MEMORANDUM
February 3, 2016

SUBJECT: Public hearing and consideration of a Landmark Alteration Certificate application to make improvements at the north end of Chautauqua Park including constructing a sidewalk along Baseline Road, improving accessibility at the King's Gate, and installing new lighting from Baseline to the Auditorium, pursuant to Section 9-11-18 of the Boulder Revised Code 1981 (HIS2015-00355).

| 1. | Site: | 900 Baseline Rd., Chautauqua Park |

Figure 12 & 13. Design concept along Baseline Road (left) and details (right) between Grant Place and 9th Street.

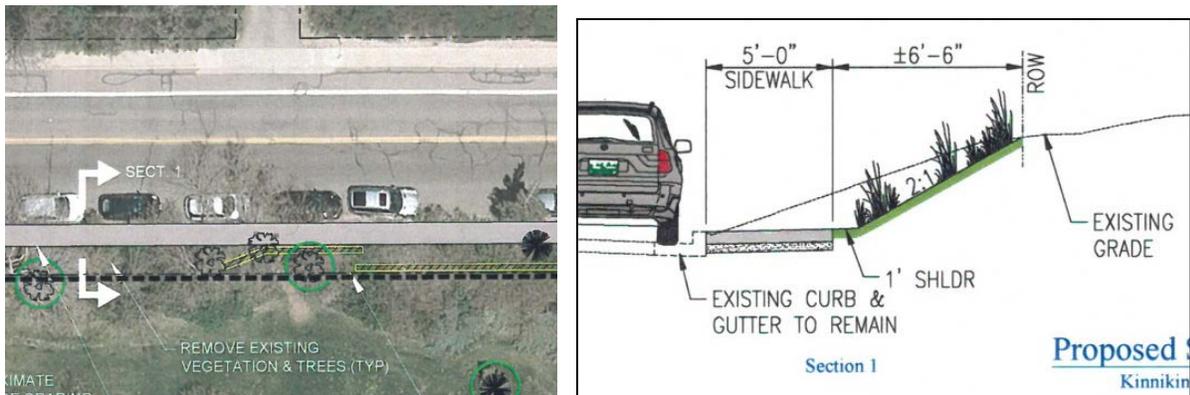
Plans show a 5 foot wide sidewalk to be constructed in the right-of-way along Baseline Road, just north of the Chautauqua Park Historic District. A section of grass that varies in width (from one to 6 feet), and varies in grade (at most a 50% upward slope) will connect the sidewalk to the higher existing grade of the Chautauqua grounds. Portions of this sloped area will be retained by a rubble stone wall to blend with the existing c.1917 rubble stone wall (outlined in yellow in plans). The submission does not include an elevation of proposed wall, but a section plan identifies it as ranging from 1 to 5 feet in height.

<p>Analysis:</p> <p>While just north and outside of the district boundary, the construction of approximately 400 lineal feet of stone retaining wall will have a visual impact on this edge of Chautauqua. While submitted plans are do not show the extent of existing stone wall along Baseline Road, staff estimates the stretch between the King’s and Queen’s gates to span approximately 150 lineal feet. The proposed new retaining wall is described as ranging from 1 to 5 feet in height, but little information has been provided as to type of stone, pattern or mortar of the proposed wall. Staff recommends that details of the new wall be brought to the Ldrc for review to ensure compatibility with the existing character of this north edge of the Chautauqua Historic District.</p>
	<p>Street Lights, Street Signs, Benches, Foundation and Other Site Furniture:</p>
	<p><i>These elements were originally simple and utilitarian, not elaborate and ornate. There are a number of companies that manufacture historic reproductions from many periods. Since the development of Chautauqua spanned several decades, there may be a good selection of appropriate site furniture; however, simplicity is the most important consideration.</i></p>

Figure 17. Section showing width & grade of sidewalk along Baseline Road between Grant Pl. and 9th Street, 2015.

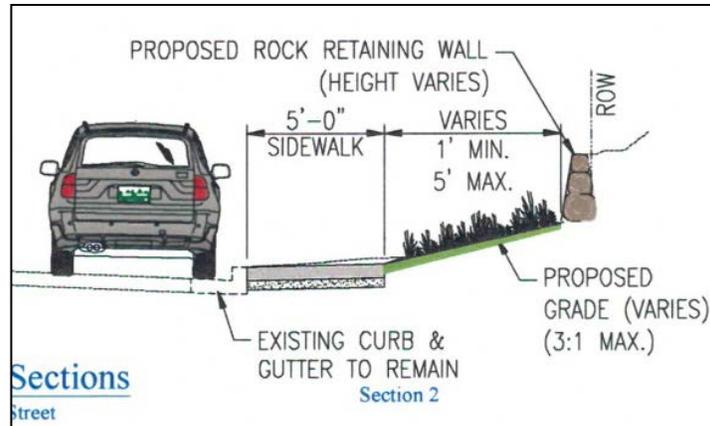
<p>Analysis: The proposed addition of 5 foot concrete sidewalk into the historic district may be inconsistent with this guideline which suggests that sidewalks in Chautauqua do not have historic precedent, and their introduction may be inappropriate. The guideline does state that drainage is a problem in the park and that “special curb and gutter” sections should be used as reference. Limiting the amount of paving in the historic district while achieving universal accessible seems an important goal. Staff suggests that consideration should be given to reducing the width of the sidewalk on the east side of Kinnikinic Road should be considered or, alternatively, providing sidewalk only on one side (perhaps the west) to achieve accessibility and minimizing the visual effect of</p>

2. Prior to submitting a building permit application and receiving final issuance of the Landmark Alteration Certificate, the applicant shall submit revised plans showing:
 - a. A reduction in the width and amount of new sidewalk along Kinnikinic Road, including the potential of constructing sidewalk on one side of that road;
 - b. Plans for the reconstructed swale that shows for that feature to closely match the historic swales in terms of material, size, depth and finish; and
 - c. Simplified lighting posts that are more compatible with the rural character of Chautauqua,
 - d. Details showing the mounted lighting on the arbor and King's Gate Shelter so that they do the least amount of damage to those structures, all in a manner that will be consistent with *General Design Guidelines for Boulder's Historic Districts and Individual Landmarks* and the *Chautauqua Park Design Guidelines*.

Figure 21. Design details for parking along Sumac Drive, 2015.

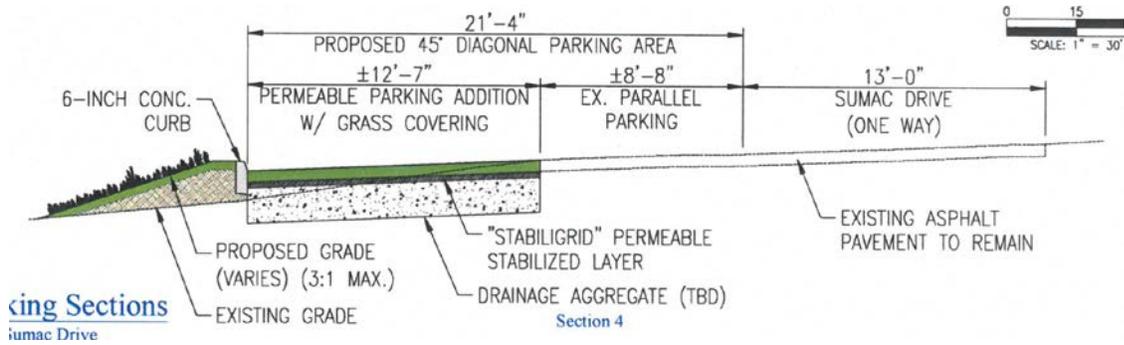
The proposed reconfiguration of angular parking along the north side of Sumac Drive is intended to allow for more parking. Plans show that Sumac Drive is currently 13 feet in width with about 8 feet of parallel parking along the north side of the road. The

modification of the parallel parking spots to the angular parking will not change the width of Sumac Drive. The angular parking will be 21 feet and 4 inches in length, encroaching onto the lawn between Baseline Road and Sumac Drive by 12 feet and 7 inches. Instead of paving the extra 12 feet with asphalt, it will instead be composed of a permeable layer with a drainage aggregate (stabila-grid) beneath a grass covering. Plans note that existing parallel parking allows for about 18 spaces and the proposed angular parking will allow for 26 spaces.

<p>Analysis: Staff considers the proposed parking improvements will allow for a modest number of new parking spaces to be provided in the park, without making a significant change to the character of the district. Details of the “Stabili-Grid” system should be reviewed and approved by the Ldrc.</p>
	<p>Sidewalks, Curbs, and Gutters:</p>
	<p><i>Streets in Chautauqua do not have the familiar sidewalks, curbs, and gutters; however, drainage and erosion is a significant problem in many locations. Drainage improvements have included special curb and gutter sections especially designed to fit the character of the park. Where drainage improvements are required, existing sandstone gutters or the special curb and gutter sections should be used as a reference. Standard formed concrete curb and gutter sections, and concrete sidewalks are generally inappropriate, and every attempt should be made to find appropriate substitutes;</i></p>

Figure 22. Proposed soft surface path from Queen’s Gate marked by red dashed line.

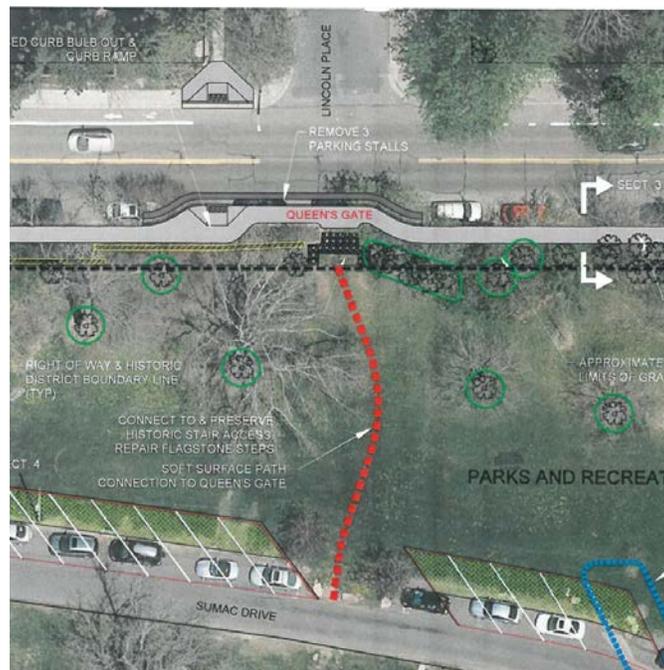
The Queen’s Gate is located along Baseline Road directly across from Lincoln Place. While the gate and its proposed improvements are located outside the Historic District boundary, the proposal calls for the construction of a soft surface path to connect the gate to Sumac Drive in the historic district boundary. No historic photos of Queen’s Gate could be located and it is unclear what kind of path may have existed. Current photos show that there is no formal path. With the pedestrian improvements along Baseline Road and to Queen’s Gate, it may be safe to anticipate a higher level of foot-traffic at this historic entrance to the grounds.

Figure 23 & 24. Left: Rendering of Arbor with proposed lighting, 2015. Right: Detail notes for arbor lighting, 2015.

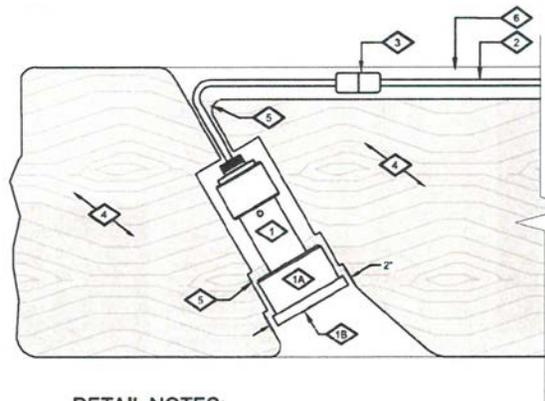
Plans propose the installation of low level lighting along key access points for pedestrian safety and to increase accessibility from Baseline Road through the major park access walks. Currently very few structures in the park are lighted. The main path from King's Gate to the Auditorium (along which the historic arbor is located) can receive a substantial amount of pedestrian traffic at night. In the lighting plan for the arbor, exterior surfaces of the arbor's stone columns are proposed to be lit by way of flood light fixtures mounted of the underside of the arbor's structural members. The downward direction of the lights is intended to create a "glow" around the columns, making it a more inviting destination at night while also increasing a sense of safety. The proposed lighting will be controlled so that it will only be on during events or certain times of the evening.

be done in a manner so that at it may be removed without damaging those historic structures. The proposal appears to remove material to install the lighting. Surface mounted lighting is more appropriate and the details of this should be reviewed by the Landmarks design review committee (Ldrc).

Figure 23 & 24. Left: Acorn-shaped proposed light fixture, 2015. Right: Bell-shaped proposed light fixture, 2015.

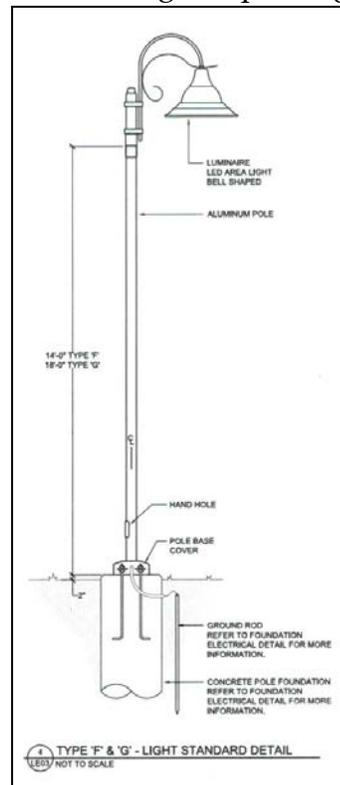
In addition to the arbor and the Trolley Station, the application requests the installation of nine lamp "acorn" lamp posts. Six of the proposed lamps have a 12 foot mounting height and are shown to be installed on the pathway south from King's Gate to the Tennis Courts. The proposed 12' lamp posts are similar to those installed in other locations, probably sometime during the 1980s. Two bell-shaped lamp posts that are 18.5 feet high to provide downward lighting, are proposed for to be installed on the eastern edge of the tennis court area, and a third bell-shaped lamp will be installed along the eastern portion of Sumac Drive near the angular parking (see map).

<p>Analysis:</p> <p>The introduction of new free-standing lighting should be simple and limited to preserve the rustic camp, like feel of Chautauqua. The introduction of the six lamp posts may have a visual effect, but that it most likely would not have an adverse effect on the overall character of the district. The introduction of the three 12 foot down lights will not negatively affect the park given their relative distance from each other. Lighting the arbor and trolley house with low wattage lighting should</p>

Figure 25. Proposed lighting plan, 2015.

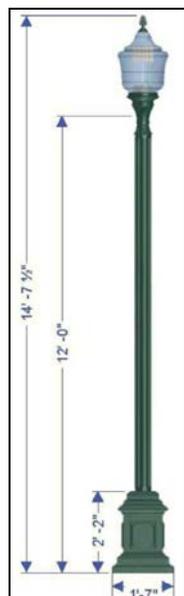
As with the drainage and paving, staff considers it important that the CCA, OSMP, Parks and Recreation jointly develop a comprehensive lighting plan for the park that can be used as the basis for the review of future lighting improvements, should they be necessary.
